ALL CONSTRUCTION GROUP

ADDENDUM NO.: 01
PROJECT NAME: North Park Village (NPV) Chapel-Building F (Bid Package 1 - Roofing)
PROJECT NO.: 04037
DATE OF ISSUE: 6/7/2023

NOTICE OF CHANGES, MODIFICATIONS, OR CLARIFICATIONS TO CONTRACT DOCUMENTS

Sheet: **G-002**

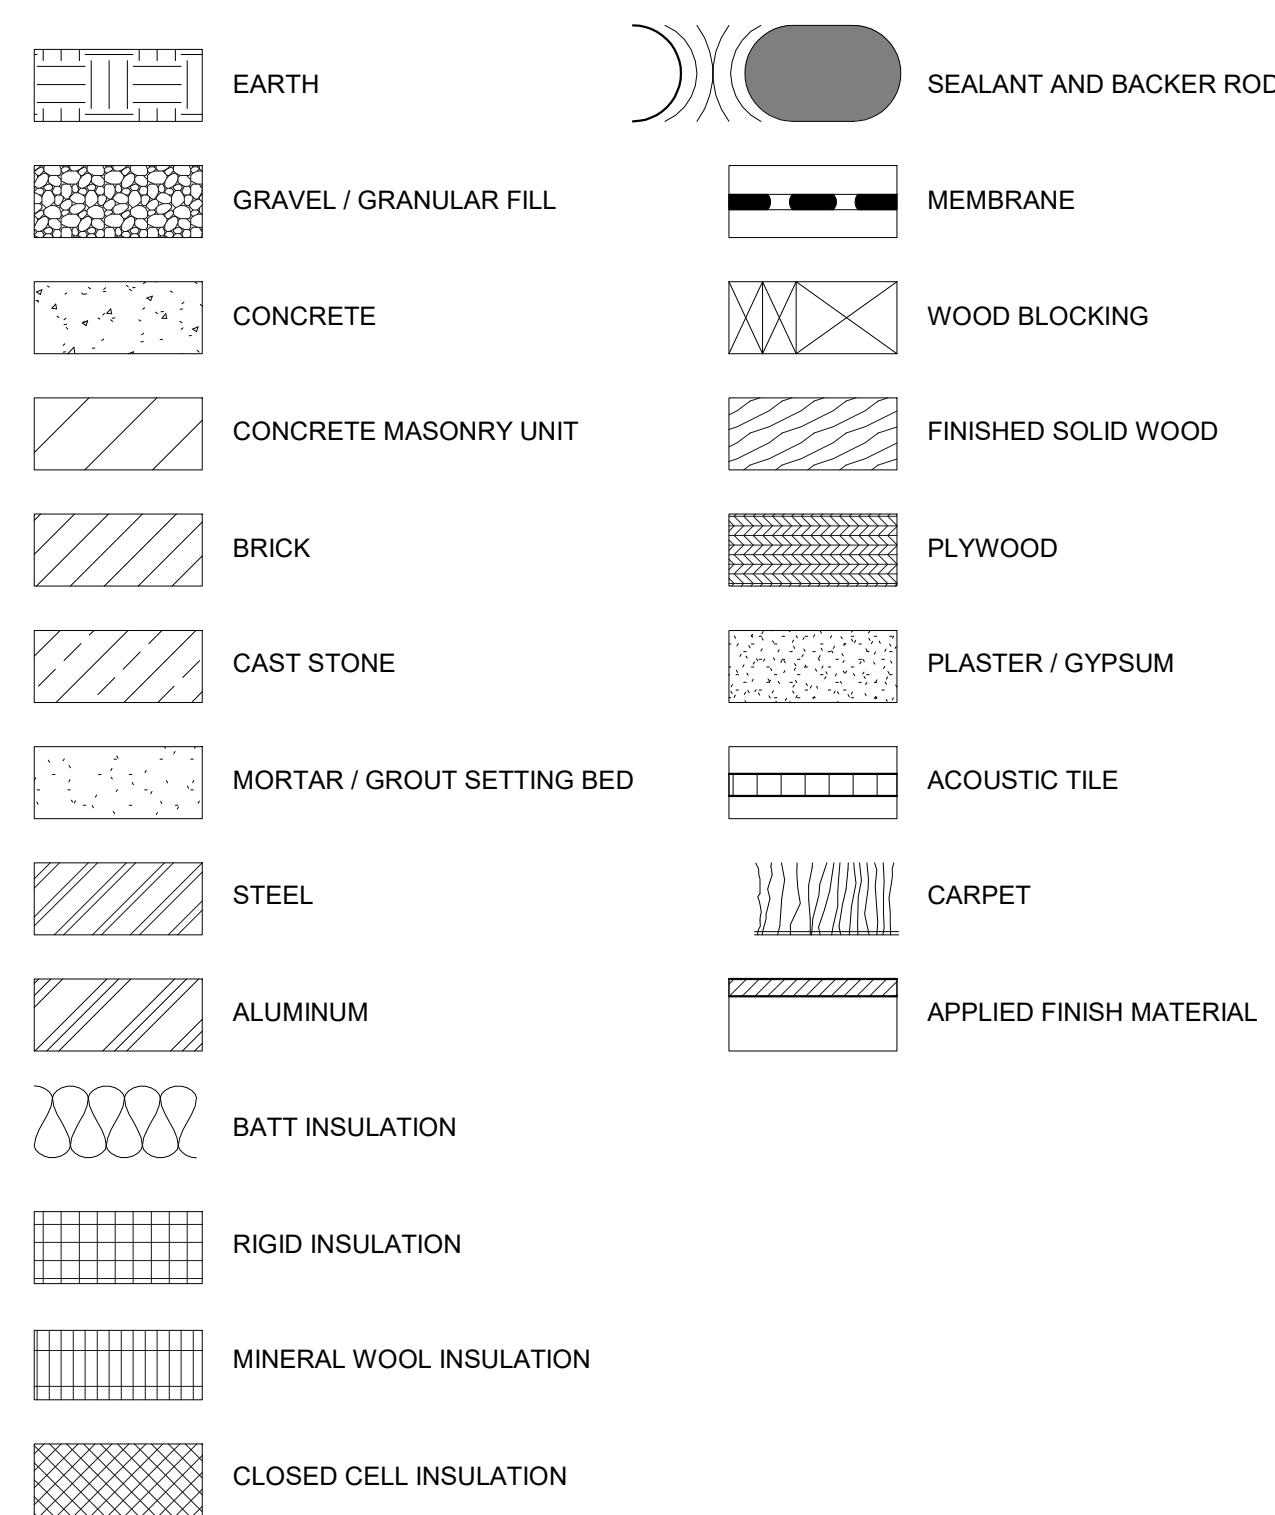
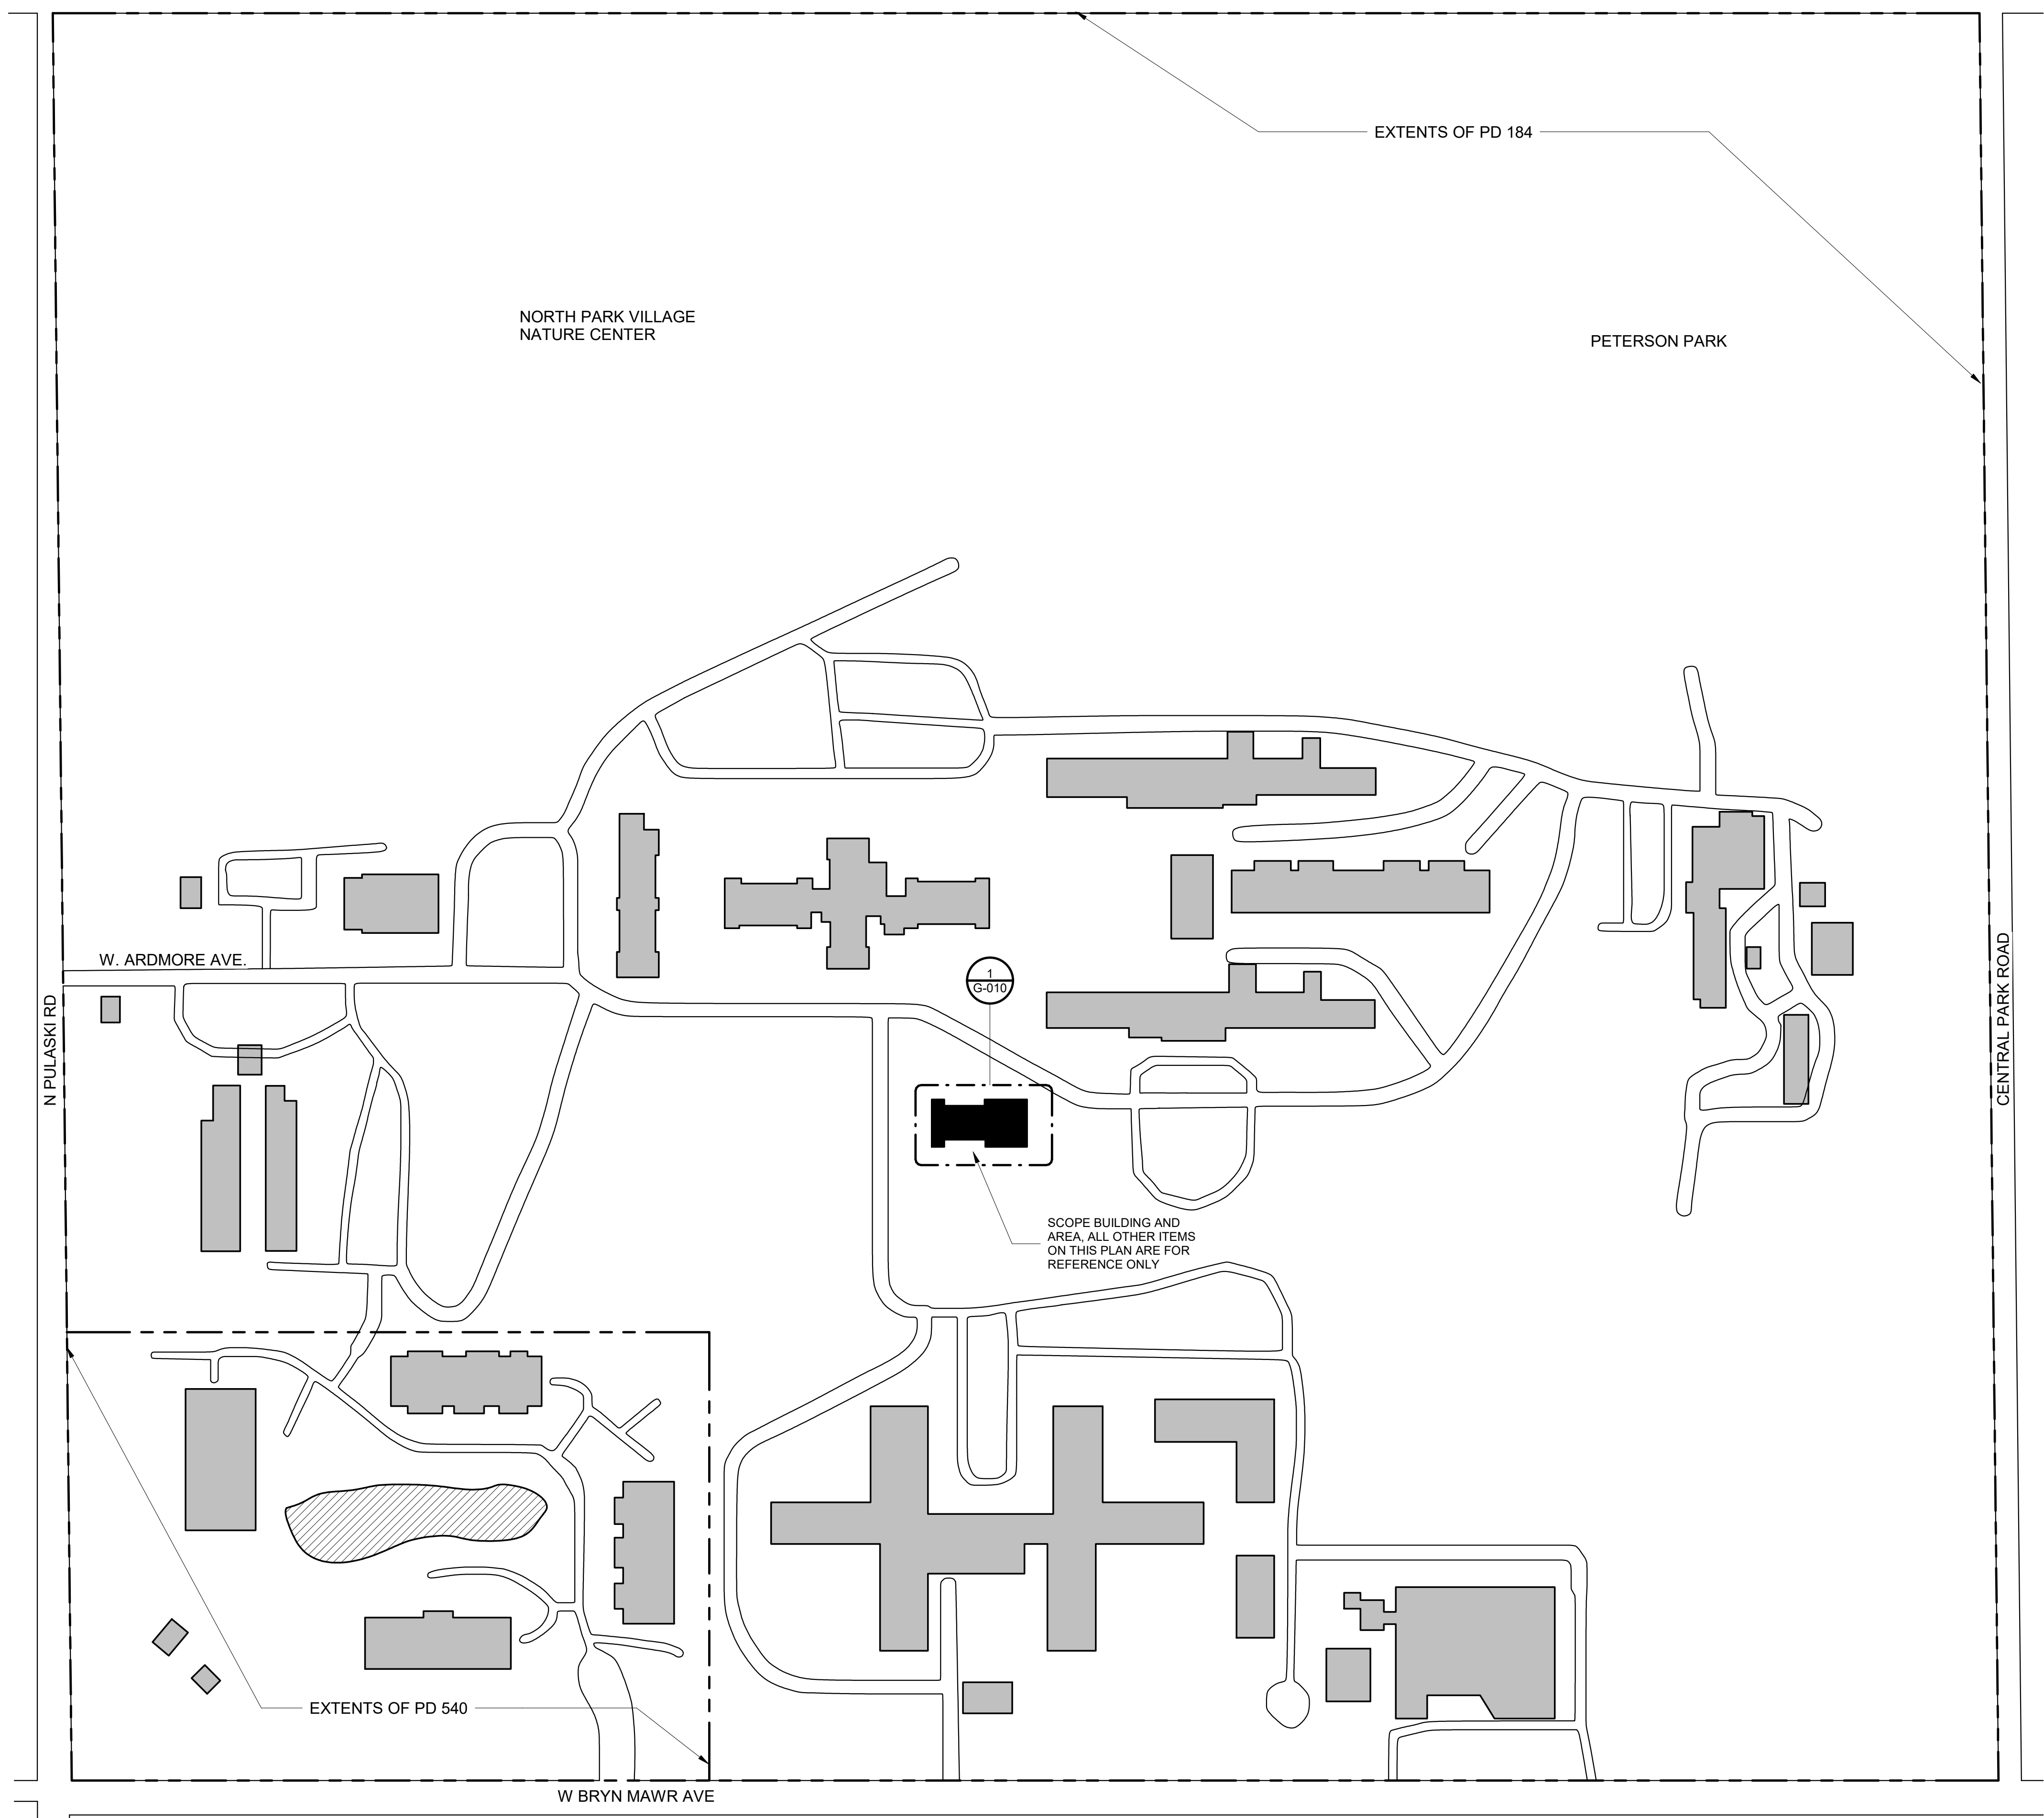
Change 2 **Revised** G002 General Notes, changed to include tree pruning guidelines.

Question 1 Will the trees be removed at the north end of the building so we can access our work? Will this be by others or does it need to be included in our price.

Answer: No, the existing trees do not need to be removed. Please refer to Note 6 on Sheet G-002 General Notes for Existing Site Elements. If tree pruning is required, please refer to Tree Pruning Notes which have been added to Sheet G-002. Sheet G-002 has been revised and is included in this addendum.

TREE PRUNING IF REQUIRED:

- ALL PRUNING SHALL BE PERFORMED BY A CERTIFIED ARBORIST
- PRUNE REMAINING TREES AFFECTED BY TEMPORARY AND NEW CONSTRUCTION AS REQUIRED.
- PRUNE REMAINING TREES TO COMPENSATE FOR ROOT LOSS CAUSED BY DAMAGING OR CUTTING ROOT SYSTEM
- PRUNE TREES ACCORDING TO ANSI A300 PART 1 AND ANSI Z133.1
- CUT BRANCHES WITH SHARP PRUNING INSTRUMENTS. DO NOT BREAK OR CHOP.
- BRANCHES REMOVED FROM TREES ARE TO BE DISPOSED OF.
- ALL PRUNING AND TRIMMING TO BE IN COMPLIANCE WITH REQUIREMENTS OF THE BUREAU OF FORESTRY

Sheet **G-010**

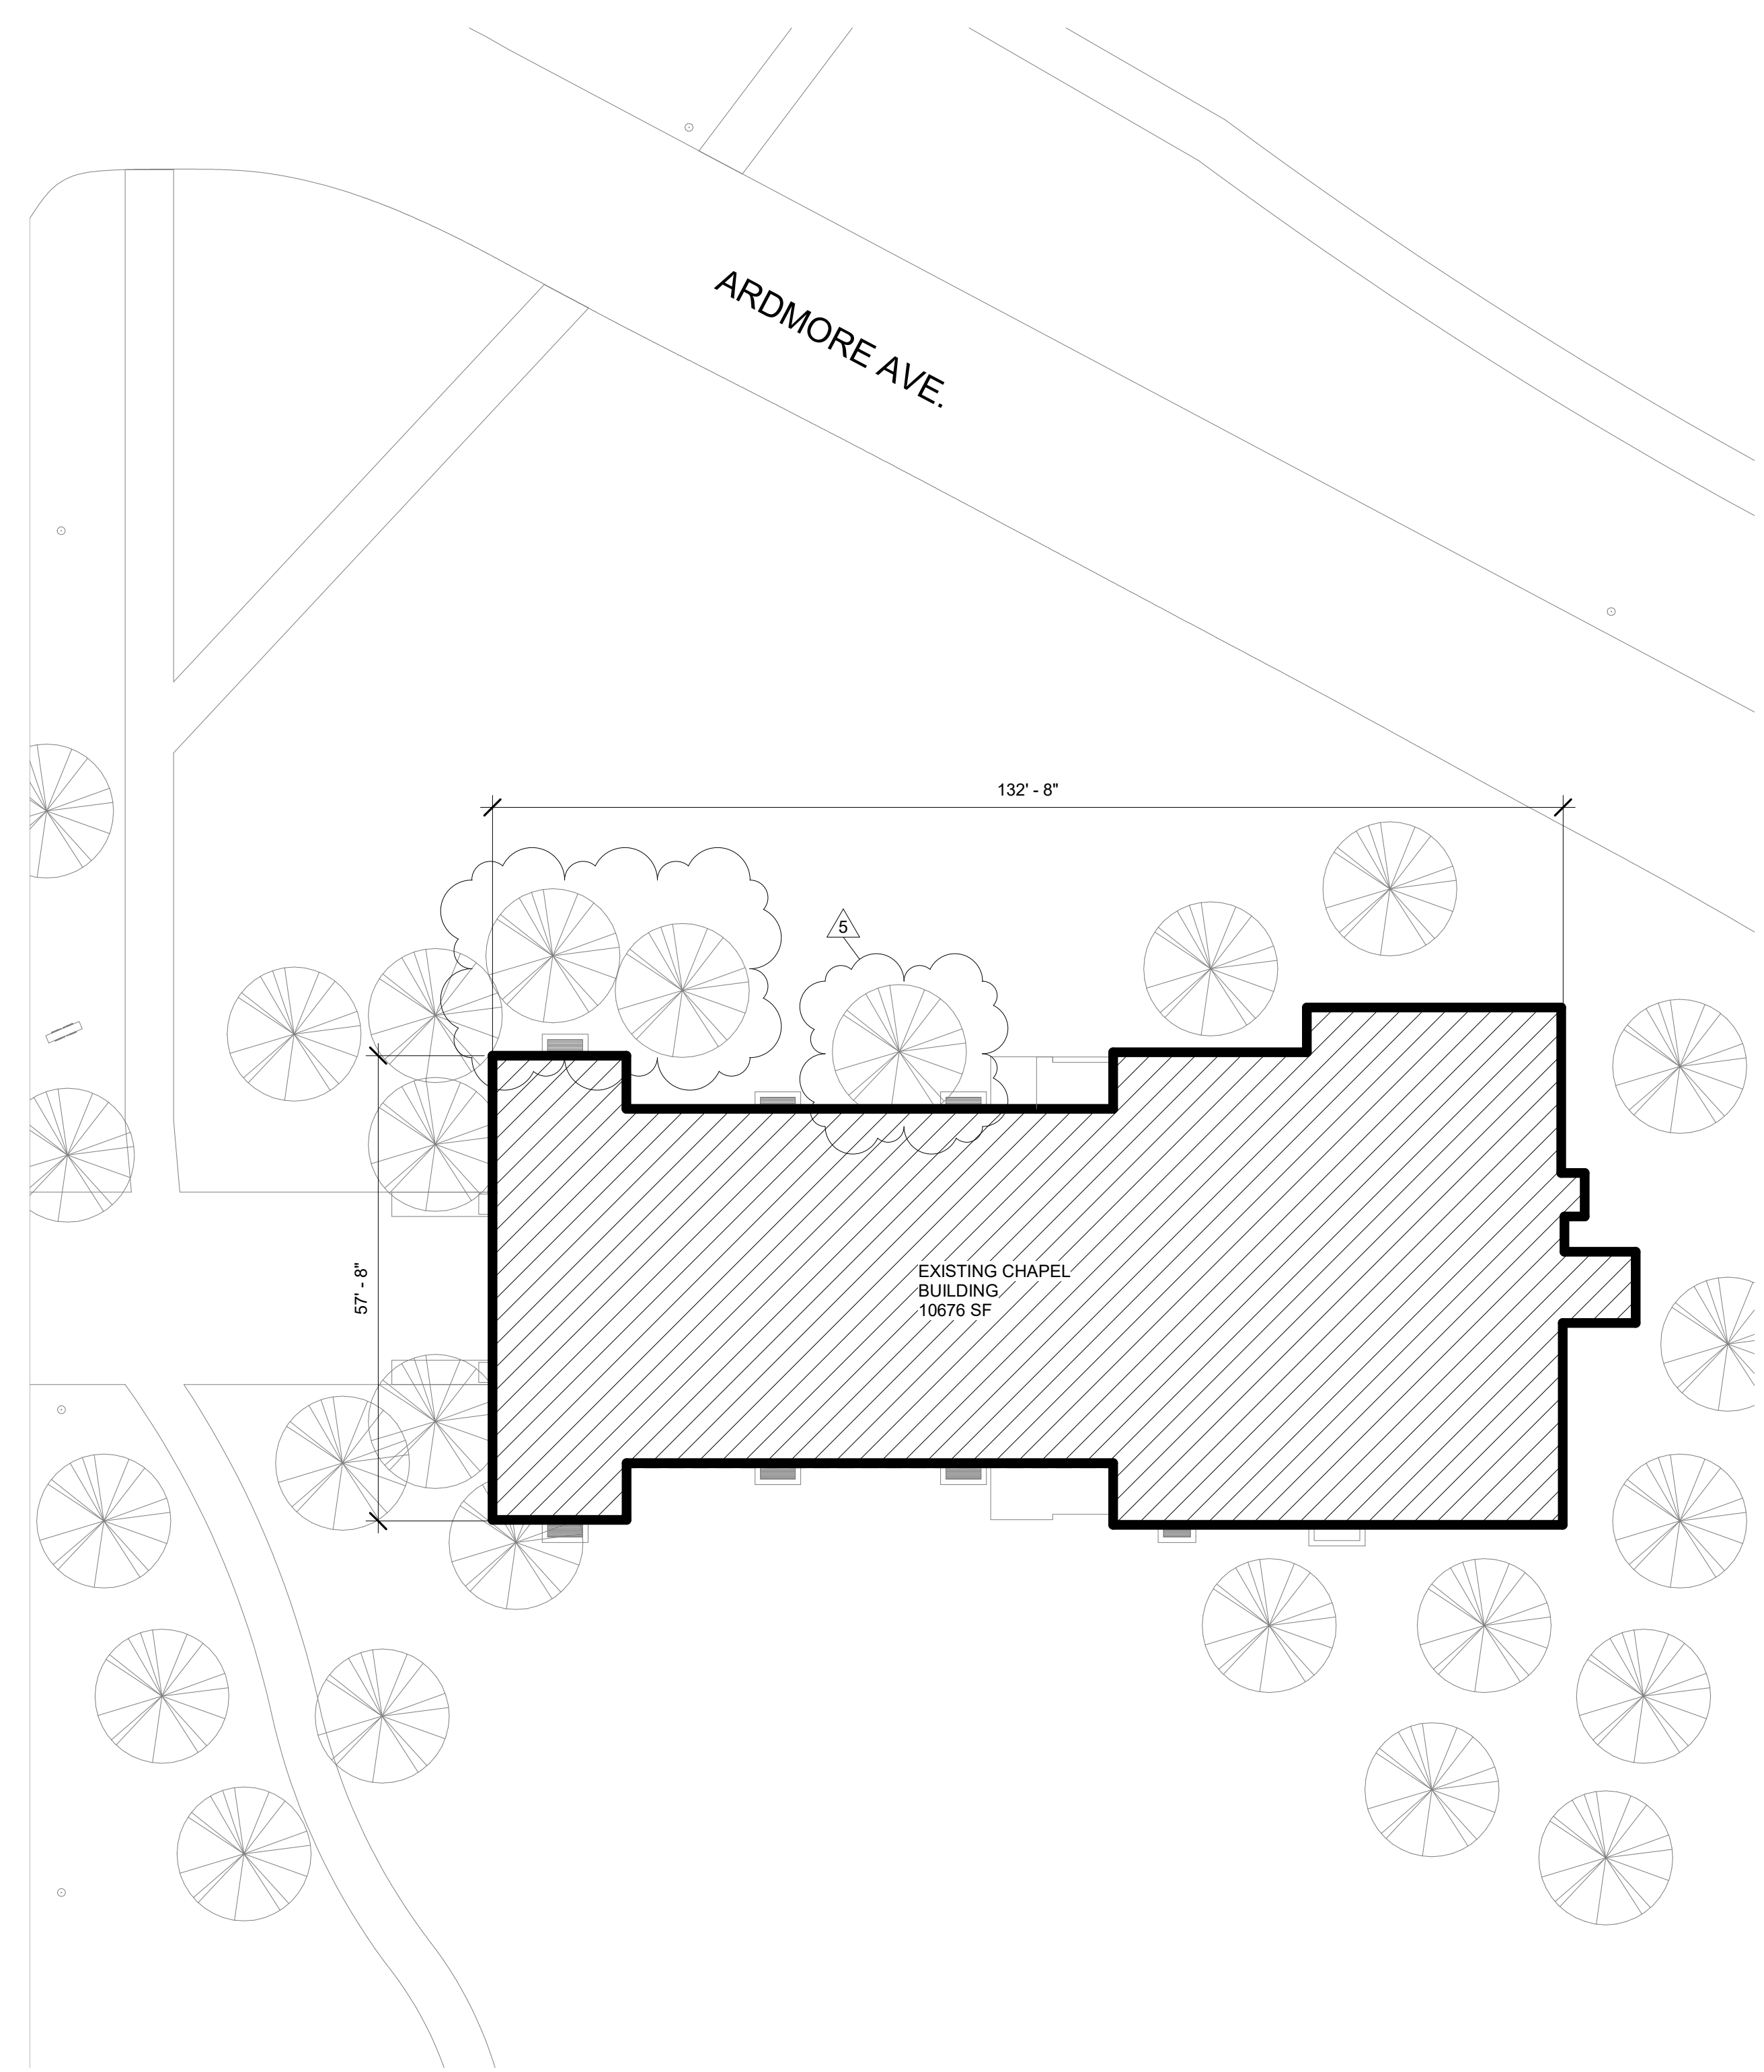
Change 3 **Revised** G-010 Site Plan, updated to reflect two additional existing trees on the north of the chapel.
